# DEALER AIDS AND DISTRIBUTION INFORMATION

SPECIAL TOOL NO.18G47BG MODIFICATION  
AND REPLACED BY 18G47BP

**ST-3**

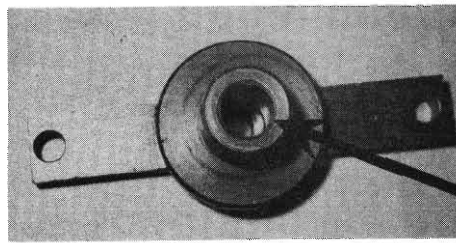
As a result of a modified first motion shaft, Tool No.18G47BG is discontinued. Tool No.18G47BP will be supplied instead. Please make note of this change in your tool listing under section, "Special Tools".

To modify the existing Tool No.18G47BG, enlarge center hole of support plate to 18mm as shown:

Enlarge ID  
to 18mm

This tool will now service original and latest type first motion shafts.
